## Parliamentary Report, 13/14 Oct 2022 flood on Maribyrnong River

1. Introduction and comments about grossly inaccurate and belated major flood warning for Maribyrnong Township by Melbourne Water
2. Maribyrnong Township flooding
3. Rivervue Retirement Village flooding as a consequence of planning revisions and multiple failures by Melbourne Water to carry out their statutory role as Responsible Drainage Authority.
4. Conclusions and Recommendation for simple solution to all flooding along the Maribyrnong River.

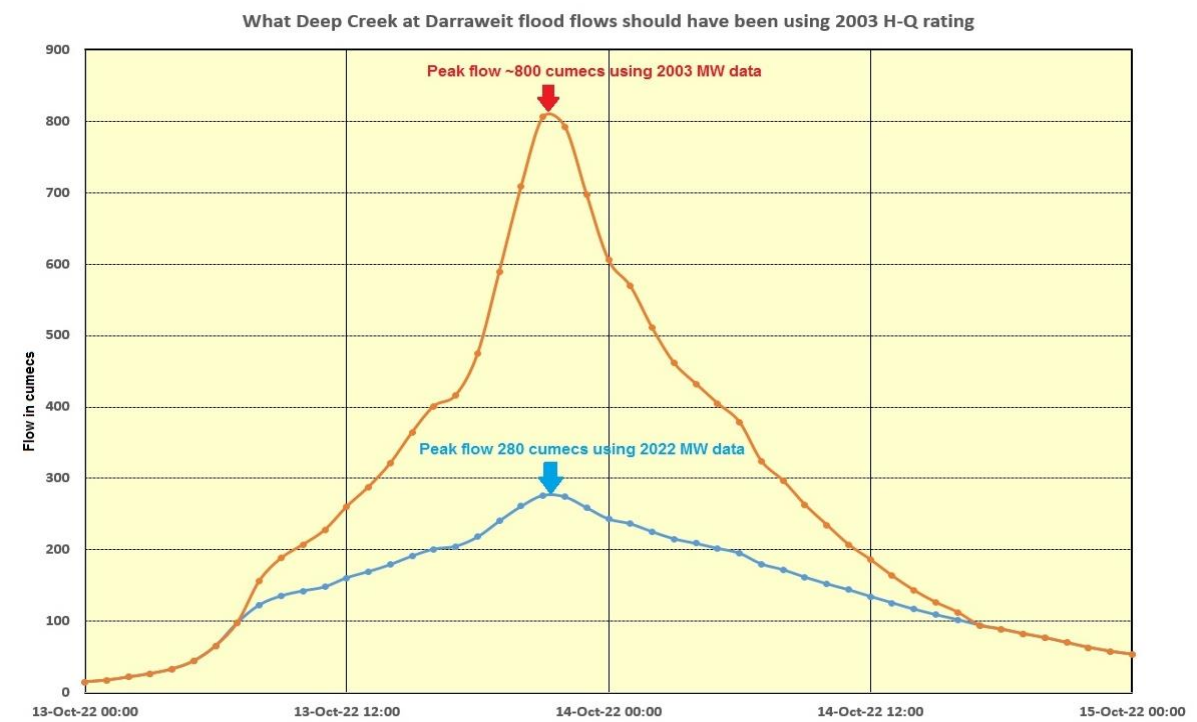
█████'s submission will contain more detail, but can be very well summed up by viewing the graph of what Melbourne Water results were at Darraweit Guim compared to █████'s far more accurate flow results; all due to Melbourne Water using an incorrect revised rating table! Melbourne Water's submission to their own flood review still does not recognise their error, something that █████ realised on the night of the flood!

This terrific graph below shows the result of flows at Darraweit Guim comparing the Melbourne Water result using their flawed rating table, compared to █████'s result using the original and accurate 2003 rating table. The error is that the new Melbourne Water rating table is wildly inaccurate in estimating flow once the river banks are overtopped. It is clearly evident that Melbourne Water incorrectly revised the flow/water height rating table and hence failed to

understand the severity of the flood and only recognised the danger to township house owners only a few minutes before their houses were inundated, some to ceiling height.

■ Newstead St. Note filling such that the slab floor is approximately one metre above flood level leaving the dwelling surrounded by flood waters.

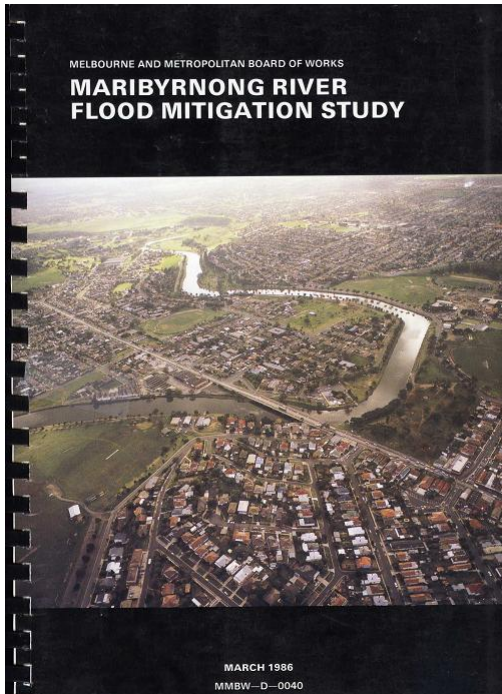
I note that a revised flood plain management (FPM) system has been used in this township whereby newly constructed houses that have their land flooded have been allowed to build multistorey dwellings in the township. An example of recent very poor flood plain management is ■ Newstead Street

This photo show the height that the 13 Oct'22 flood reached in the Maribyrnong Township, 4.2m AHD and as can be seen, that is some 2.2m above ground level.

This approval by Maribyrnong Council of the Newstead property is contrary to common sense and definitely contrary to FPM principles. Residents would have to stay indoors up to 3 days in a significant flood. This practice should be stopped and the Water Minister should immediately advise Melbourne Water and Maribyrnong Council to obey the Water Act. **It is ridiculous to have residents trapped inside a building surrounded by water nearly one metre deep, and expect them to stay in the house for several days during a flood, or have the SES rescue them by boat.** This nonsense of proper FPM also occurs in Brisbane and is just plain wrong. I understand that planning revisions have also been changed such that the drainage authority (Melbourne Water) is not always advised of a construction proposed in a declared flood area. Clearly this is wrong and the practice should be immediately stopped by the relevant Minister.

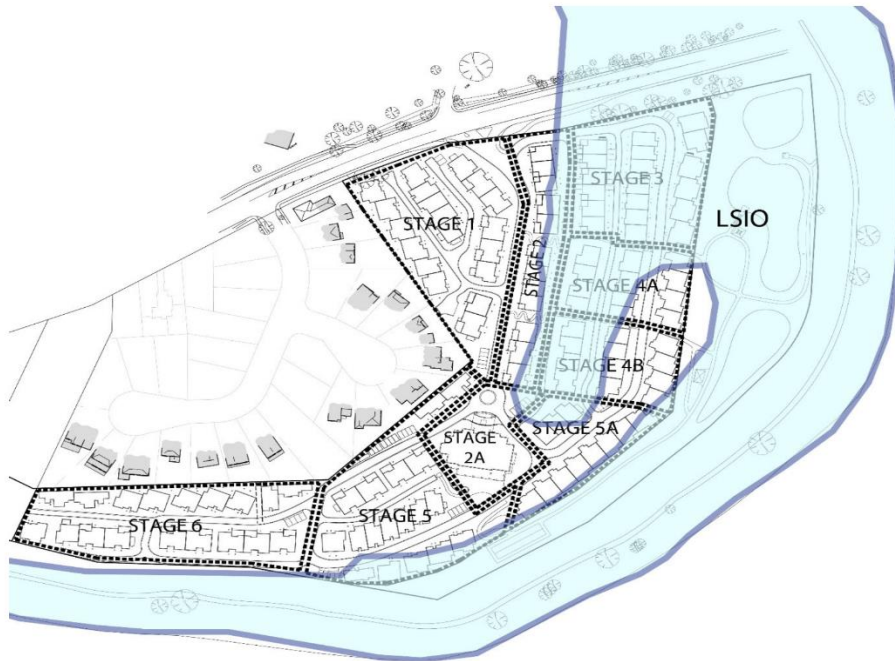
approved the dwelling construction with conditions such that floor levels had to be 600mm higher than the flood level of 6.6m AHD (Australian Height Datum). This meant that flood waters could flow down the streets serving these dwellings. Melbourne Water strangely never attended the VCAT hearing in 2006 and only provided written advice to Council. VCAT subsequently approved the plan for these 47 dwellings and included Melbourne Water's conditions relating to floor levels being 600mm higher than the flood level.

Velocity \* Depth ratio. The VD ratio was used to limit use of roadways used as floodways. A VD had to be less than 0.6, with velocity limited to 1m/sec and depth no more than 0.6 metre.

Retirement Villages are used by retired people, generally by the elderly who may or may not need assistance to traverse these roads. In my experience dealing with planning permit applications in the 80s and 90s, I considered it far too dangerous to allow roadways in retirement villages to be used to convey flood waters. The VD limit of 0.6 was derived from model studies at Monash University and related to the conditions when a car would float. Obviously it is way too dangerous for a retired and limited mobility person to enter a roadway with moving floodwaters. Hence I never approved such designs for retirement constructions. However, Melbourne Water in 2006 did approve it!

*Photo of Rivervue Retirement Village, showing the constructed retarding basins in the area of the site close to the river corridor land. Canning Street is seen at the right of photo.*

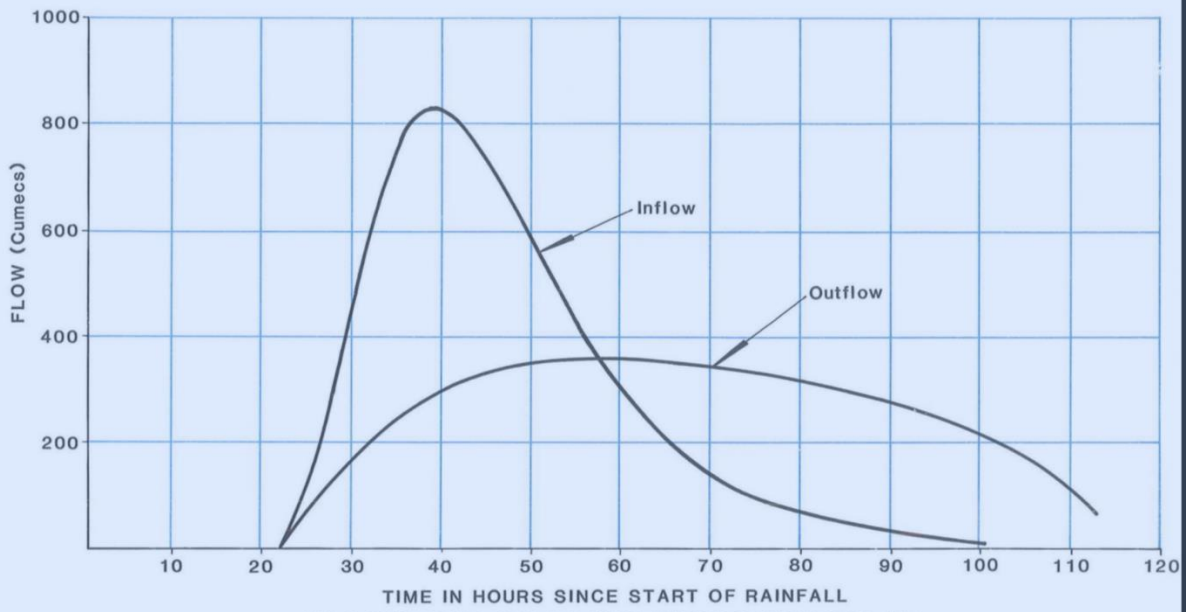
After 2006, ownership of the village changed hands to TIGCORP. **In 2015, there was a major and very damaging change to the planning controls.** TIGCORP had engaged consultant, [REDACTED] to examine flooding up stream of Canning St on the Maribyrnong River. The 100 year flow was reduced and the area occupied by the new smaller flow was reduced. Melbourne Water amazingly agreed with these changes and applied to Council under planning amendment C151, headed by [REDACTED] as the sole decider, and the LSIO was subsequently changed in 2015 as shown on the plans below. This meant that the land where the 47 units were proposed was no longer covered by the revised LSIO. A quick look at the plans below shows that the LSIO was moved about 80 metres away from the proposed dwellings. There was, strangely, flood mitigation works consisting of two small ponds that are supposed to work as mini retarding basins. The aerial photo below shows the area today. These plans for the relocation of the LSIO, the resultant freeing of a flood zone for the 47 dwellings, and the "retarding basins", was all approved by Melbourne Water. History of the 13 Oct'22 flood clearly shows that the revised flow and area inundated as shown by the new LSIO is clearly wrong. The Oct22 flood easily flooded the area where the 47 dwellings are now built and extended approximately up to the original LSIO. The ponds constructed to reduce flooding as shown in the photo below, are not going to make any difference to flows. They are simply two small ponds filled with water and hence cannot possibly act as retarding basins. There would be no volume available to flood flow to have any hope of working as retarding basins. It staggers me to think that Melbourne Water actually approved such nonsense design.

Despite the revised lower discharges and levels calculated by TIGCORP and approved by Melbourne Water in 2015, the 13 Oct'22 flood event flooded land as depicted by the previous LSIO! The 2022 flood event is regarded as a 50 year event whereas an LSIO is for a 100 year event. **Obviously the revised LSIO is hugely wrong.** The 47 dwellings were built about 900mm lower than the 2006 VCAT requirements. The 2006 VCAT requirement was to build the floor levels of the 47 units 600mm higher than the flood level of 6.6m AHD. The 2015 revision was to build 300mm above the revised flood level of 6m AHD, hence comparing  $6.6 + 0.6 = 7.2$  m floor level to the 2015 result of  $6 + 0.3 = 6.3$  m AHD, compare 7.2m to 6.3 is a 900mm difference. All 47 units were flooded to approximately 500 mm flood depths inside these houses. Despite the Water Act requesting that new dwellings built after 1975 be free of flooding, these dwellings were built after 2015 and had extensive damage. It seems little point in rebuilding these dwellings as they have been shown to flood in a 50 year event. Typically these 47 dwellings are valued at about \$800,000. The owners have advised me that the village insurance is very limited and they fear it is inadequate. **TIGCORP recently in their submission to Melbourne Water's review has admitted that the insurance cover is inadequate to rebuild the 47 dwellings. There is very little point in rebuilding these dwellings as they obviously could easily flood again in the future.** I regard Melbourne Water as the culprit in the Rivervue disaster. They failed to appear at the 2006 VCAT and should never have approved the 47 dwellings they were surrounded by flood waters, they failed to properly assess the consultant engaged to redo the discharges and area inundated in 2015, and failed to take an active interest in this development. They requested a change to the LSIO that is clearly in serious error and hence must accept the blame for damage done.

INFLOW AND OUTFLOW HYDROGRAPHS AT ARUNDEL RETARDING BASIN FOR 100 YEAR FLOOD EVENT

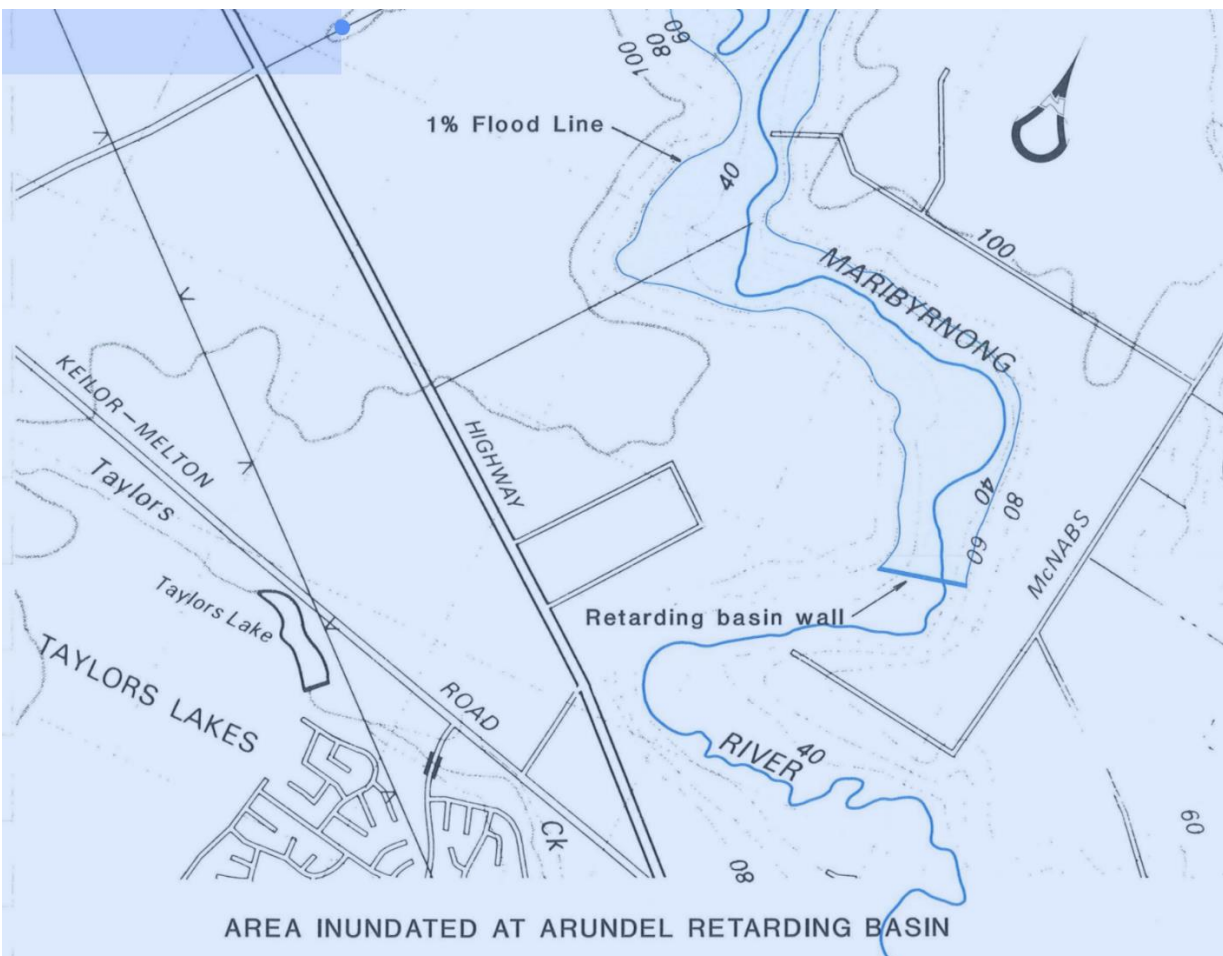
The 1986 report was very extensive and considered various solutions to flooding on the Maribyrnong. These included various levee banks and several retarding basin locations. The overwhelming best option was to build a retarding basin at ARUNDEL. This would be located on rural lands just north of Keilor and capture flows from the two main tributaries, Deep Creek and Jacksons Creek. The intention was to do feasibility designs of the basin such that it would temporarily retard 100 year flows and discharge flows to not exceed the capacity of the natural Maribyrnong channel downstream. Hence all flooding downstream of the basin, and particularly the Maribyrnong Township, where flooding of some 500 dwellings would be eliminated.

The hydrograph below shows the 100 year flow, 840 cumecs, being reduced to 350 cumec. The retarding basin ended up 34m high with a piped outlet 5.4m diameter. A big element is the design of the spillway that needs to conform with a 10,000 year storm where lives are at risk.
